DEPARTMENT OF TRANSPORTATION
FEDERAL HIGHWAY ADMINISTRATION

DOCKET NO. FHWA–2020-0001
NATIONAL STANDARDS FOR TRAFFIC CONTROL DEVICES; THE MANUAL ON UNIFORM TRAFFIC
CONTROL DEVICES FOR STREETS AND HIGHWAYS; REVISION

COMMENTS OF
THE ASSOCIATION OF AMERICAN RAILROADS
AND THE
AMERICAN SHORT LINE AND REGIONAL RAILROAD ASSOCIATION

**Comments on Docket No. FHWA-2020-0001 National Standards for Traffic Control Devices;
the *Manual on Uniform Traffic Control Devices for Streets and Highways*; Revision**

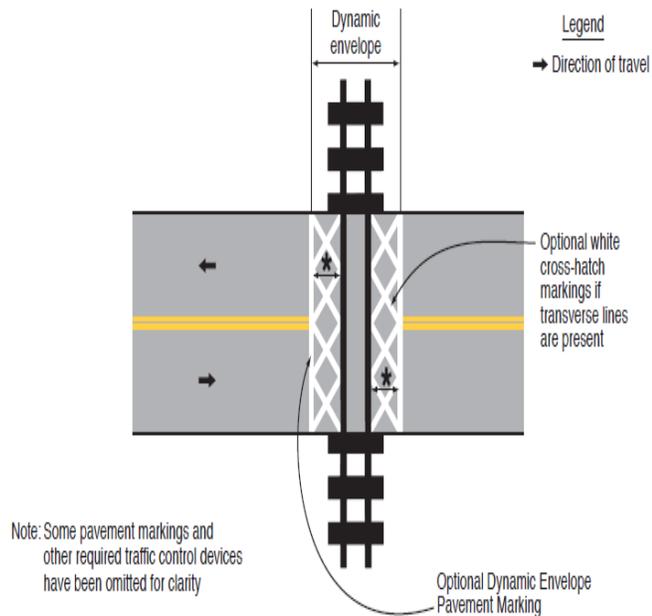
Next, AAR/ASLRRA recommends FHWA delete Figure 8C-4 and its reference in this section (line 48 of page 704), because the markings are more clearly addressed in Figure 8C-3 and in Part C (Figure 8C-4 as proposed has the potential to cause confusion). Last, AAR/ASLRRA also recommends FHWA revise Figure 8C-3 to include an additional clarifying explanation regarding coordination between road authorities and the railroad or transit agency (to read as follows):

The proposed AAR/ASLRRA amendment to Figure 8C-3 is reflected in blue text in the figure below:

* The distance between the rail and the dynamic envelope pavement marking should be equal to 6 feet unless otherwise advised by the operating railroad or light rail transit agency.

If crossing surface maintenance or approach roadway maintenance is required or performed which alters the markings, the removal or replacement of the markings should be coordinated between the road authority and the railroad or transit agency.

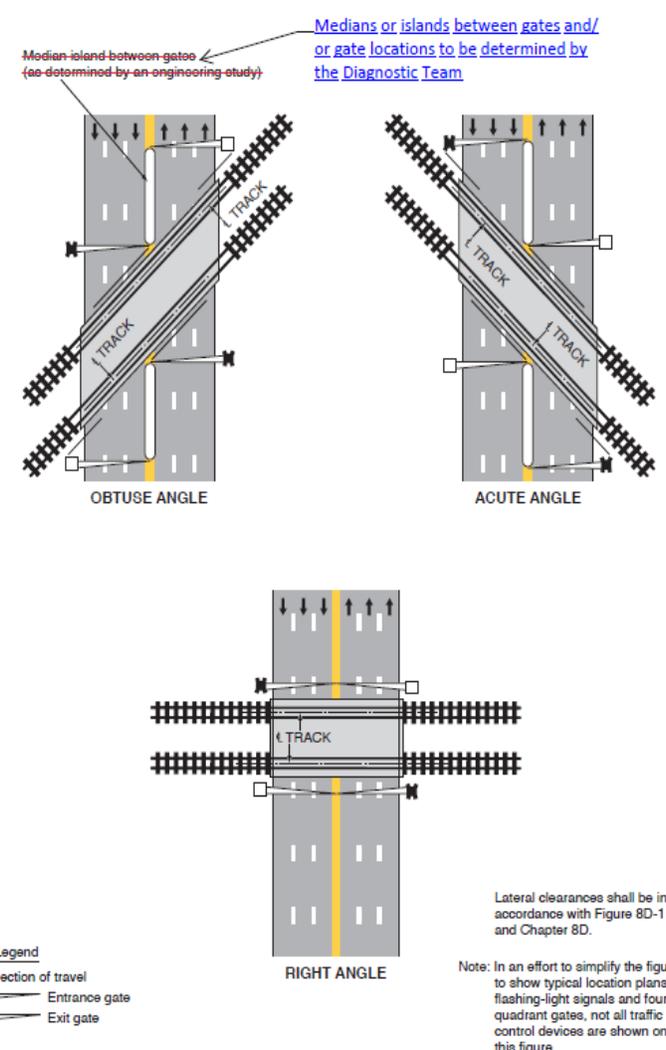
<p>Next, this section also references Figure 8D-2. AAR/ASLRRA recommends that for the “obtuse angle” drawing in Figure 8D-2, that FHWA delete the proposed language accompanying that drawing and instead describe that:</p> <p>“Medians or islands between gates and/or gate locations to be determined by the Diagnostic Team.”</p> <p>AAR/ASLRRA recommends this change for purposes of consistency with Section 8D.01, and because a Diagnostic Team with benefit of railroad representation can more appropriately determine a median or island between gates. The proposed AAR/ASLRRA amendment to Figure 8D-2 is reflected in red text/strikethrough and blue text in the drawing below:</p>  <p>The figure consists of three diagrams illustrating track crossings. The top-left diagram is labeled 'OBTUSE ANGLE' and shows two tracks crossing a road at an obtuse angle. A red annotation points to a yellow median island between the gates, stating 'Median island between gates (as determined by an engineering study)'. A blue annotation points to the same area, stating 'Medians or islands between gates and/or gate locations to be determined by the Diagnostic Team'. The top-right diagram is labeled 'ACUTE ANGLE' and shows two tracks crossing a road at an acute angle. The bottom diagram is labeled 'RIGHT ANGLE' and shows two tracks crossing a road at a 90-degree angle. A legend below the diagrams defines symbols: an arrow for 'Direction of travel', a black rectangle for 'Entrance gate', and a white square for 'Exit gate'. A note at the bottom right states: 'Lateral clearances shall be in accordance with Figure 8D-1 and Chapter 8D. Note: In an effort to simplify the figure to show typical location plans for flashing-light signals and four-quadrant gates, not all traffic control devices are shown on this figure.'</p>

Figure 8D-2	NO	YES	N/A	See the proposed amendments to Figure 8D-2 in the discussion of Section 8D.05 directly above.
8E.02	NO	YES	N/A	FHWA should replace the word “pedestrians” in the Support statement on page 729 (line 42) with the word “user”. Bicycles and wheelchairs are referenced in this Support statement (page 729 at

Figure 8E-2. Example of Placing Sidewalks on the Outside of the Gates at a Perpendicular Grade Crossing

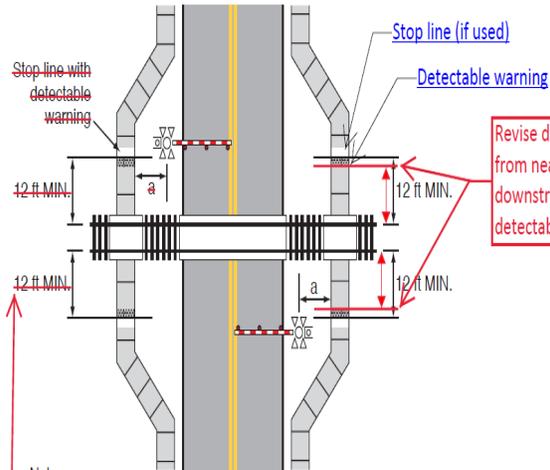
Next, this section references Figures 8E-2 and 8E-3. AAR/ASLRRA recommends those figures be revised as follows (proposed amendments in red text and blue underlined additional language). AAR/ASLRRA makes these requests so the figures are consistent with our comments on section 8E.04 further below (dimensioning in all Chapter 8E text, with figures revised to provide measurements from “nearest rail” for consistency purposes):

If a >25 ft, Crossbuck Assemblies should be installed on the approaches to the sidewalk grade crossing (see Section 8E.05).

Remove duplicate dimensions on this side of the roadway

Figure 8E-4. Example of Signing and Markings at a Pathway Grade Crossing

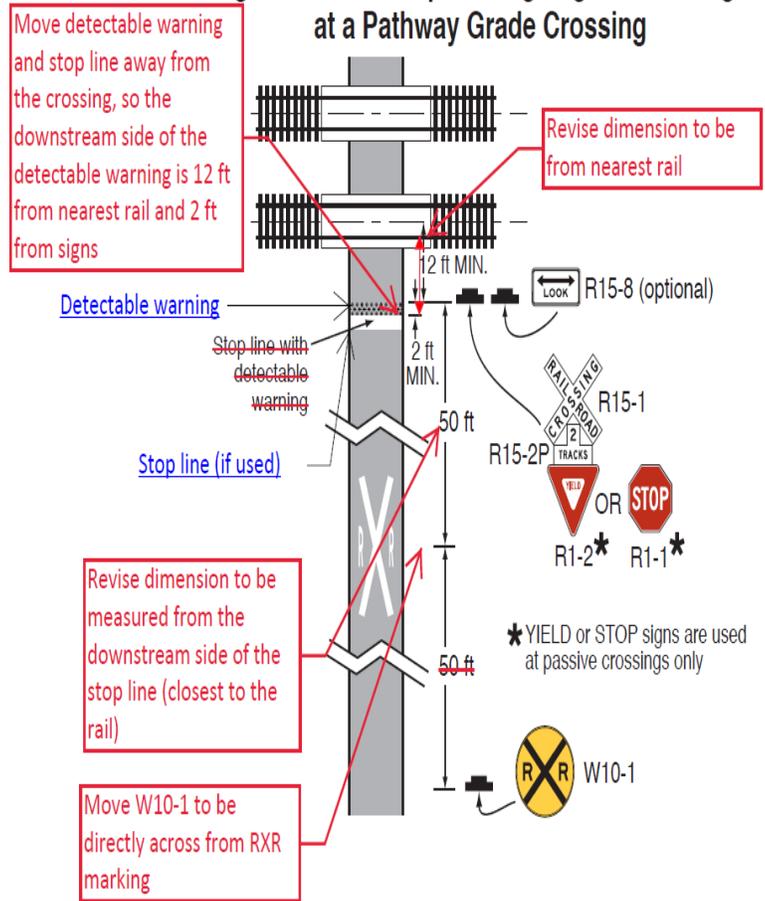
8E.04	NO	YES	N/A	<p>AAR/ASLRRA recommends that the proposed Guidance statement in this section on page 731 (at lines 20-24) be revised to read as follows (proposed AAR/ASLRRA additions underlined, strikethrough reflecting proposed deletions):</p> <p>“If used at pathway or sidewalk grade crossings, the stop line should be a transverse line <u>that extends across the full width of the pathway or sidewalk</u> at the point where a pathway or sidewalk user is to stop. If no detectable warning is provided, tThe stop line should be placed at least 2 feet upstream from the automatic gate, counterweight, flashing-light signals, or Crossbuck assembly (if any of these are present), and at least 12 feet <u>perpendicular</u> from the nearest rail.</p> <p>AAR/ASLRRA recommends this amendment so the Guidance statement is consistent with the detectable warning standards and to clarify that the dimensions cited are only applicable if detectable warning is not provided.</p> <p>Next, in a following Guidance statement in this section on page 732 at lines 4-12, AAR/ASLRRA recommends that the discussion be revised to read as follows (proposed AAR/ASLRRA additions underlined, strikethrough for proposed deletions):</p> <p>“The width <u>upstream to downstream dimension</u> of the detectable warning should be at least 2 feet.</p> <p>Detectable warnings should be placed immediately downstream from the pathway or sidewalk stop line <u>approaching the grade crossing</u> (if a stop line is present) or should be incorporated into and made a part of the stop line. The downstream edge of the detectable warning <u>adjacent to the grade crossing</u> should be located <u>at least 2 feet upstream from the automatic gate, counterweight, flashing-light signals, or Crossbuck assembly (if any of these are present), and at least no less than 12 feet perpendicular</u> from the center of the nearest track <u>nearest rail</u> (see Figures 8E-4).</p> <p>If the distance between the centers of two adjacent tracks at a sidewalk or pathway grade crossing is more than 38 feet <u>30 feet or more measured from the inside rail to the inside rail</u>, additional detectable warnings should be used to designate the limits of the pedestrian refuge area (see Figure 8E-5).”</p> <p>AAR/ASLRRA recommends these revisions for purposes of clarity and for consistency with the Guidance statement for stop lines appearing elsewhere in this section. The proposed revisions would also amend all dimensions in Chapter 8E to reference the “nearest rail” for consistency purposes.</p> <p>Next, this section references Figure 8E-4. AAR/ASLRRA requests FHWA adopt the below amendments to this figure (additions reflected in red text/strikethrough and blue underlined additional language). These amendments are intended so Figure 8E-4 is consistent with the proposed text of Section 8E.04 as proposed in this comment, and to show the dimensions from the nearest rail and the sign placement consistent with Section 8C.02:</p>

Figure 8E-5. Example of Pedestrian Gate and Emergency Exit Gate Placement at a Pathway Grade Crossing

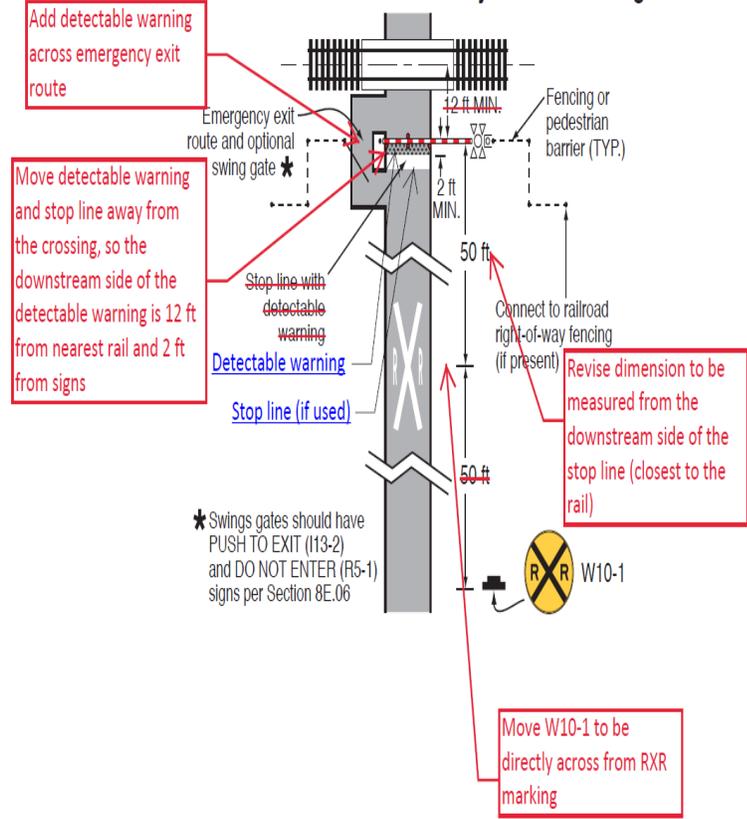
<p align="center">8E-5 Figure 8E-6. Example of a Refuge Area and Detectable Warnings at a Sidewalk Grade Crossing</p> <p><i>Revise dimension to be from nearest rail</i></p> <p><i>Remove the sidewalk from the left side of the figure because it is not relevant to the purpose of this figure</i></p> <p><i>* If A is more than 30 feet, additional detectable warnings should be used (see Section 8E.04)</i></p> <p><i>If A is 30 ft or more, detectable warnings should be used between tracks to delineate a refuge area for pedestrians who are visually impaired</i></p>
Figure 8E-4	NO	YES	N/A	See the proposed amendments to Figure 8E-4 in the discussion of Section 8E.04 directly above.
Figure 8E-5	NO	YES	N/A	See the proposed amendments to Figure 8E-5 (including correction to the designated figure number) in the discussion of Section 8E.04 directly above.
8E.06	YES	N/A	N/A	AAR/ASLRRA agrees with proposed Section 8E.06. However, this section references Figures 8E-7 and 8E-8. AAR/ASLRRA recommends a correction to the figure number from that published by FHWA for Figure 8E-7 (which was labeled Figure 8E-5. See discussion in Section 8E.04 above). AAR/ASLRRA also recommends amendments (AAR/ASLRRA's proposed additions reflected in red text/strikethrough and blue underlined additions) to Figure 8E-7 to show dimensions from the nearest rail and to show sign placement consistent with Section 8C.02:

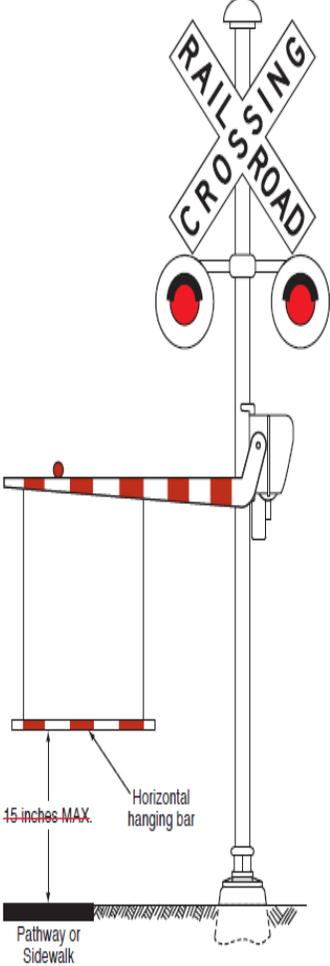
AAR/ASLRRA requests FHWA amend Figure 8E-14 to to reflect our comment on the Guidance statement addressing horizontal bar height in this section (as discussed directly above for page 737 on lines 43-45). AAR/ASLRRA's proposed amendments to Figure 8E-14 are reflected in red strikethrough in the figure below:

Figure 8E-11	NO	YES	N/A	See the proposed amendments to Figure 8E-11 in the discussion of Section 8E.09 directly above.
Figure 8E-14	NO	YES	N/A	See the proposed amendments to Figure 8E-14 in the discussion of Section 8E.09 directly above.
